# CITY OF DULUTH

Community Planning Division

<b>File Number</b>	PL 18-158	<b>Contact</b>	Kyle Deming, <a href="mailto:kdeming@duluthmn.gov">kdeming@duluthmn.gov</a>	
<b>Type</b>	MU-I Planning Review	<b>Planning Commission Date</b>	January 8, 2019	
<b>Deadline for Action</b>	<b>Application Date</b>	December 4, 2018	<b>60 Days</b>	February 4, 2019
	<b>Date Extension Letter Mailed</b>	December 20, 2018	<b>120 Days</b>	April 3, 2019
<b>Location of Subject</b>	1012 E. Second St. (St. Luke's Building A)			
<b>Applicant</b>	St. Luke's Hospital – Mike Boeselager	<b>Contact</b>	<a href="mailto:mboeselager@slhduluth.com">mboeselager@slhduluth.com</a>	
<b>Agent</b>	Erdman Company – Tim Casey	<b>Contact</b>	<a href="mailto:tcasey@erdman.com">tcasey@erdman.com</a>	
<b>Legal Description</b>	PID 010-3830-05080			
<b>Site Visit Date</b>	December 26, 2018	<b>Sign Notice Date</b>	December 24, 2018	
<b>Neighbor Letter Date</b>	December 21, 2018	<b>Number of Letters Sent</b>	69

Requested is a Plan Review associated with the MU-I plan for the St. Luke's Campus. The proposal includes:

ATTACHMENT C.1

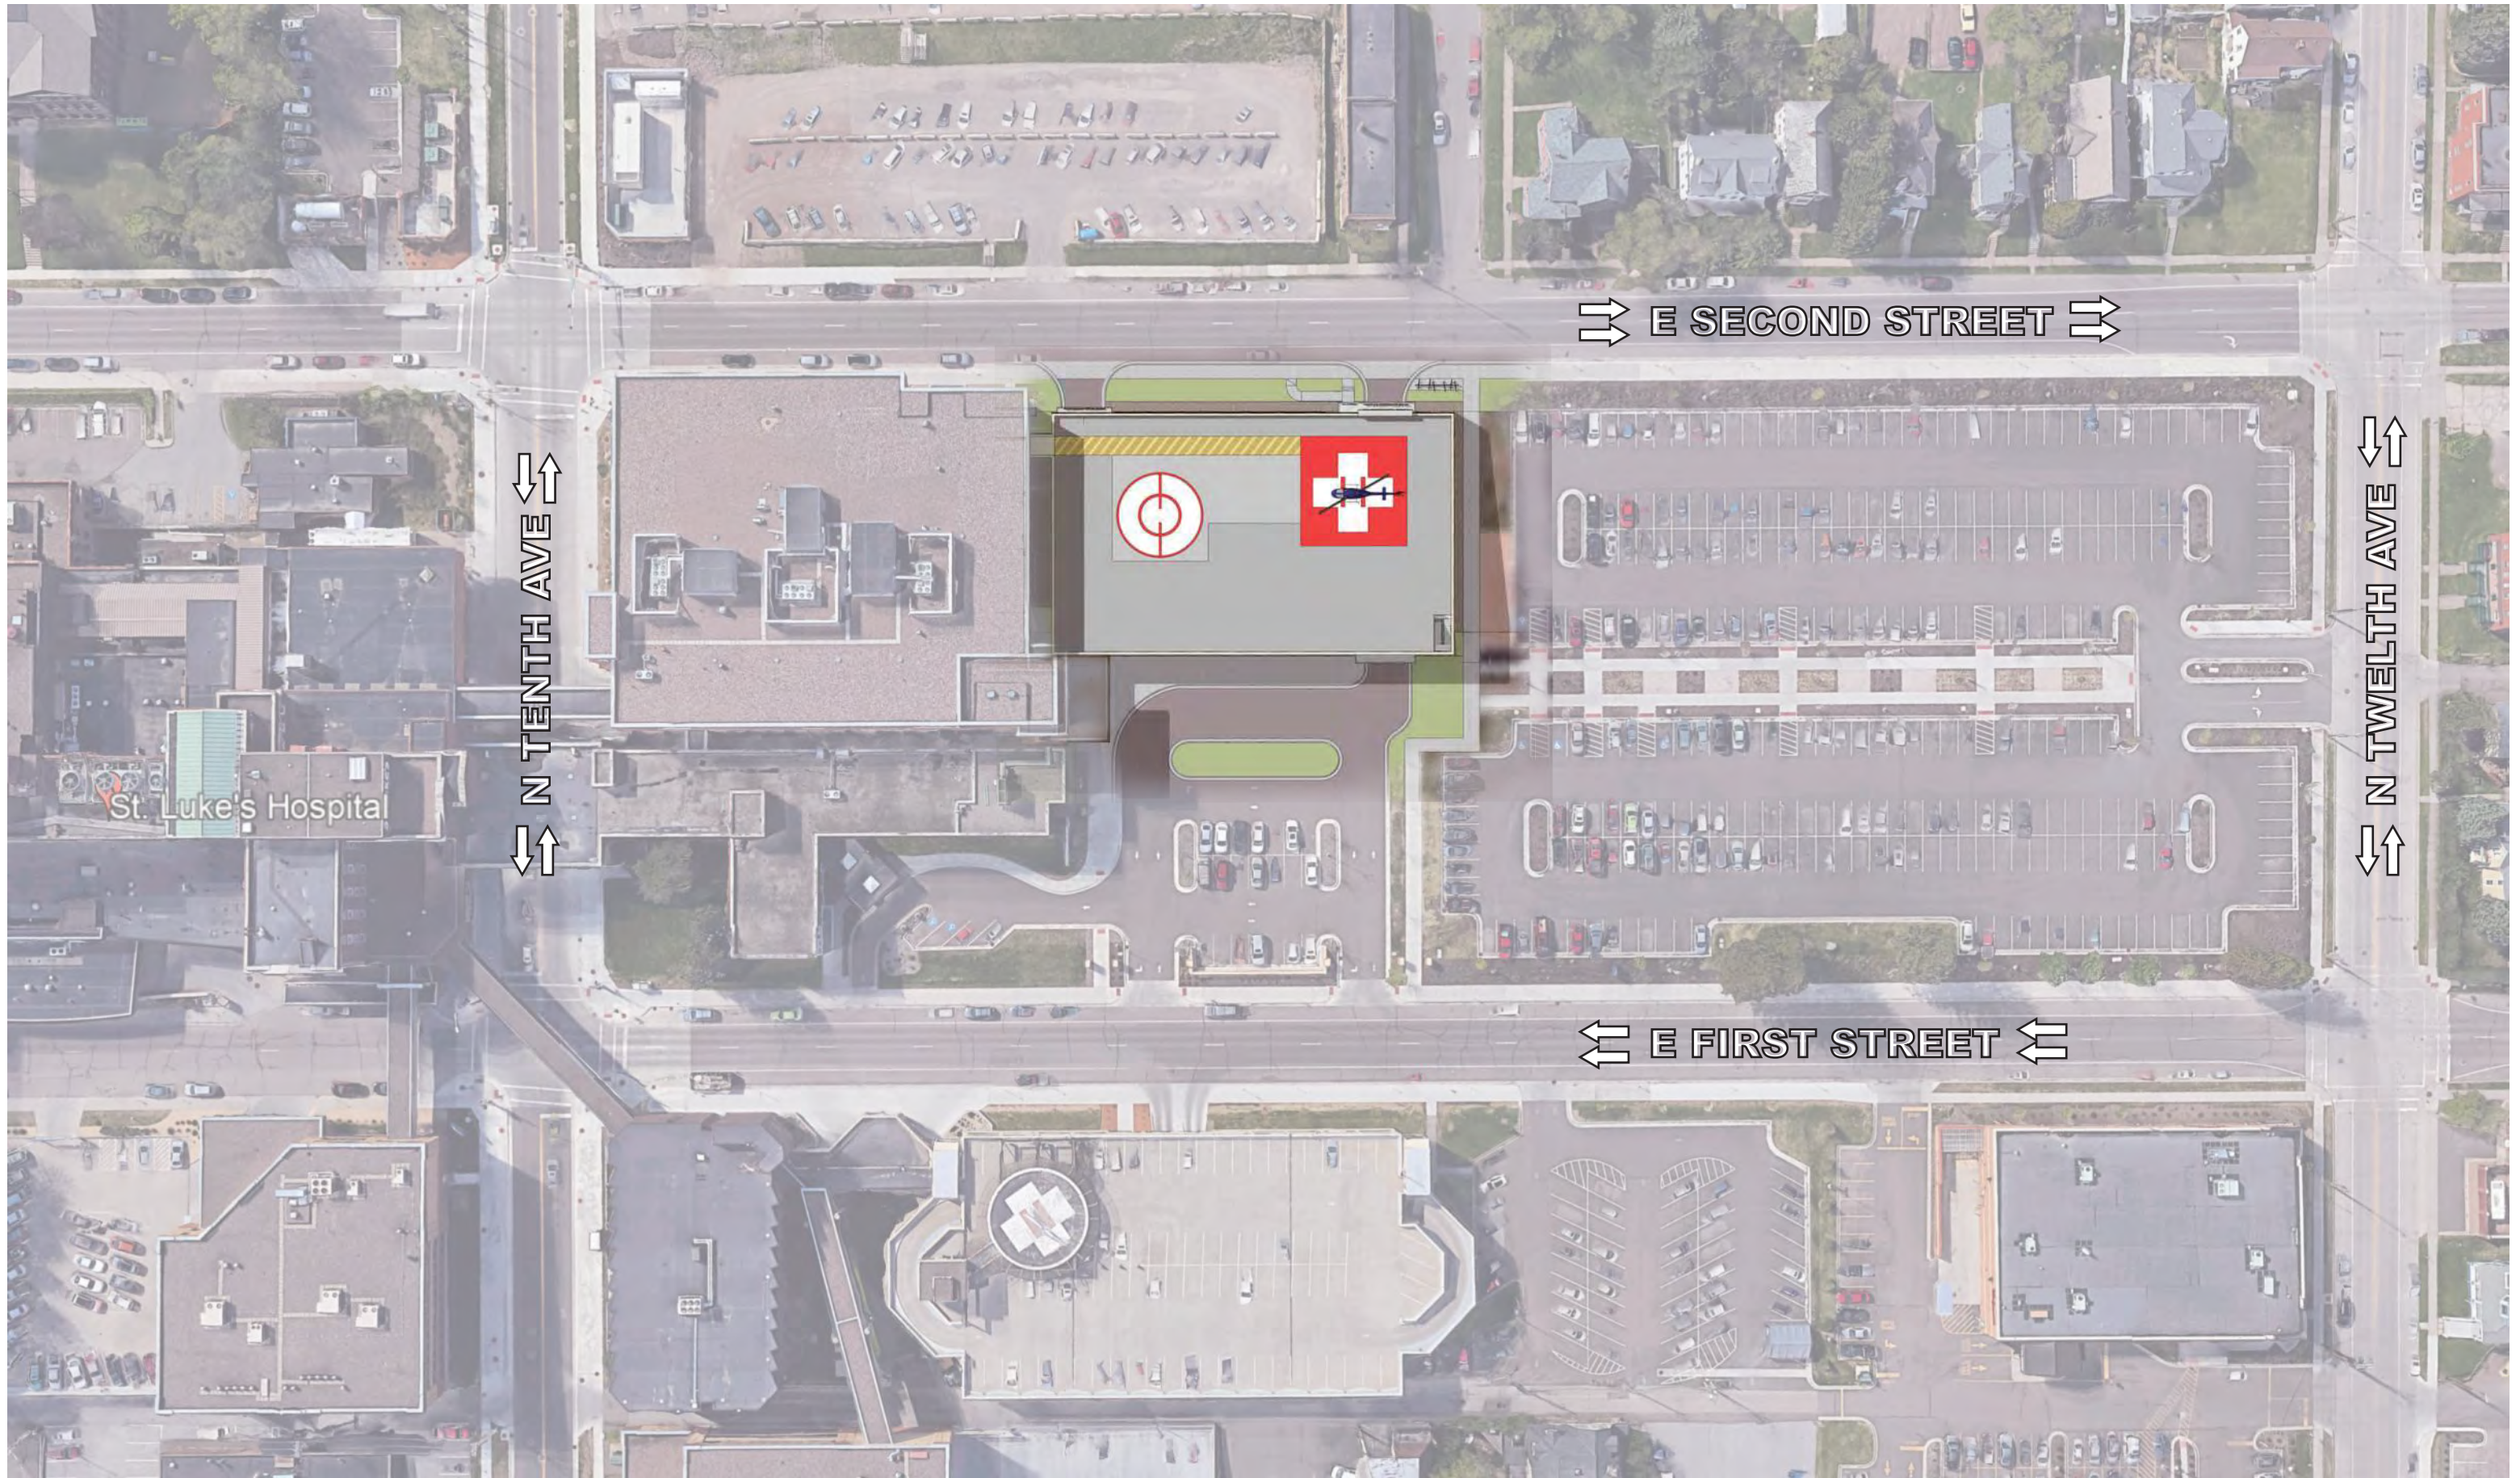
- 4) The applicant provide to the Land Use Supervisor revised landscape and storm water plans (Attachments C.1, C.2, and C.3) before application for a building permit to show additional landscaping (street trees) that meet UDC requirements and storm water improvements to the parking lot on the north side of E. 2<sup>nd</sup> St. that are approved by the City Engineer;

ATTACHMENT C.3

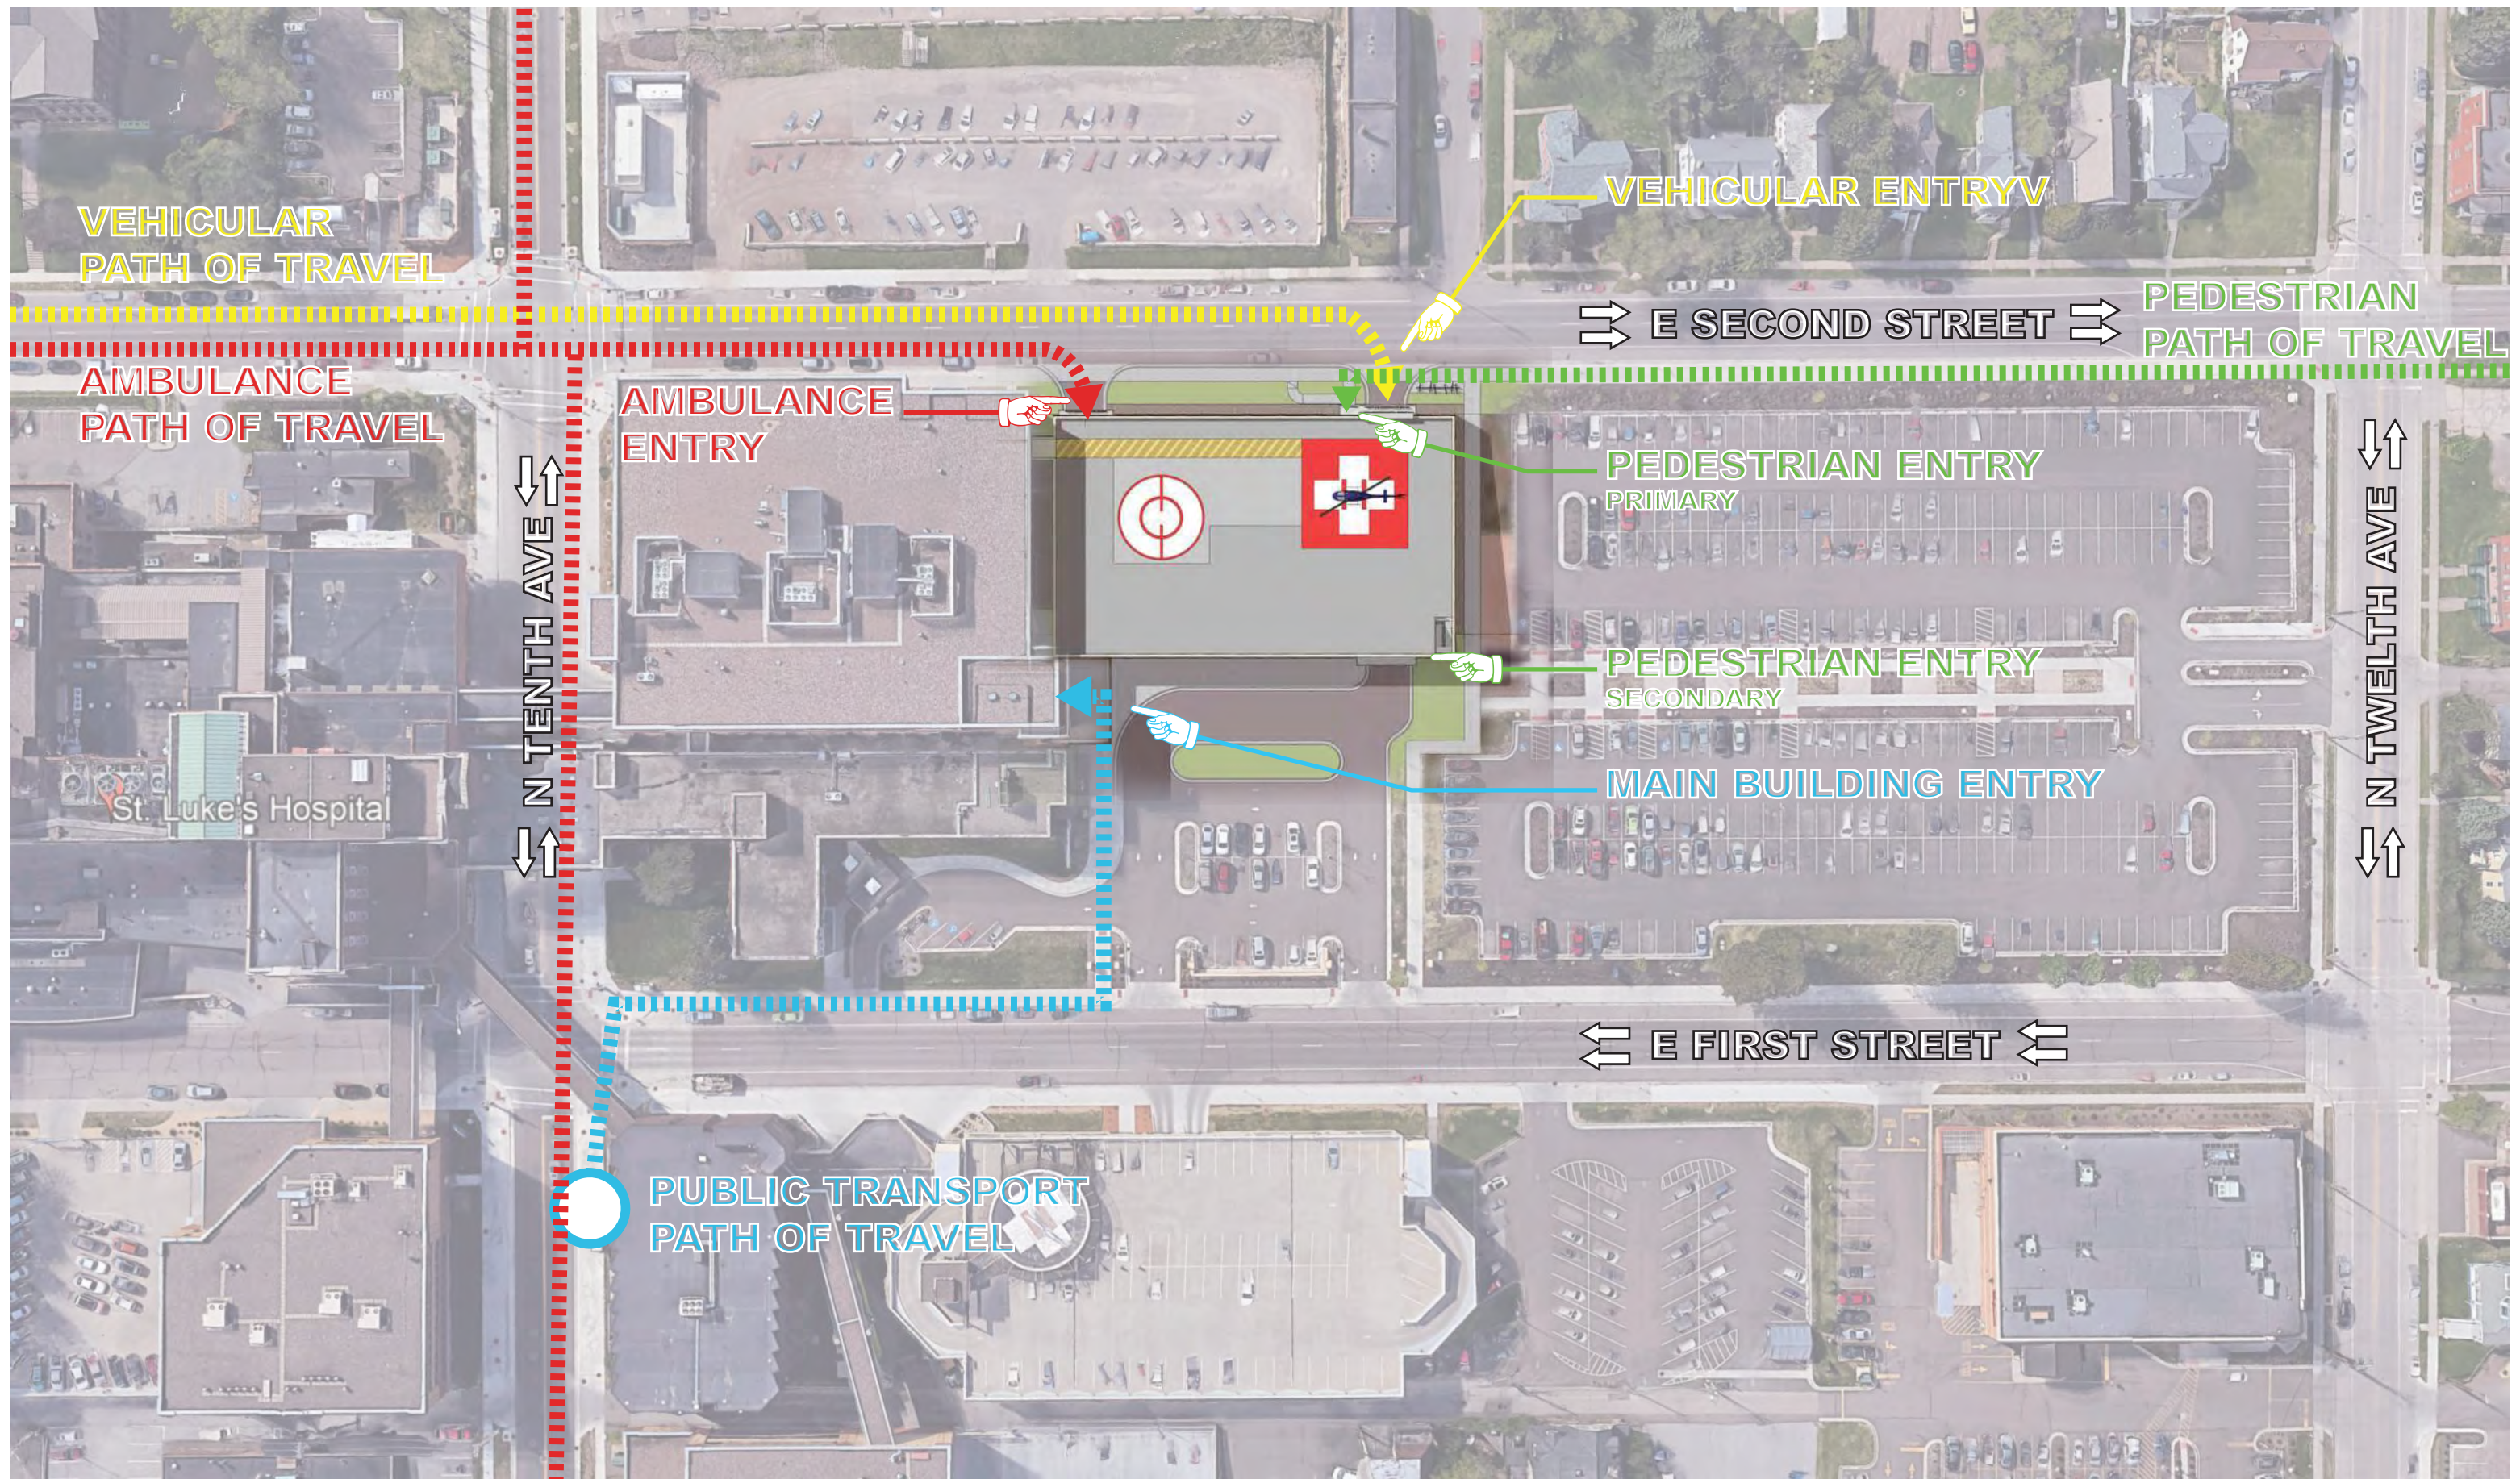
7) 50-25 (Landscaping and Tree Preservation) – Attachment C.3 is the landscape plan described by paragraph 14 of the applicant's submittal. The proposal provides required street frontage landscaping for the new structure as well as the improved parking lot on the north side of E. 2<sup>nd</sup> St.
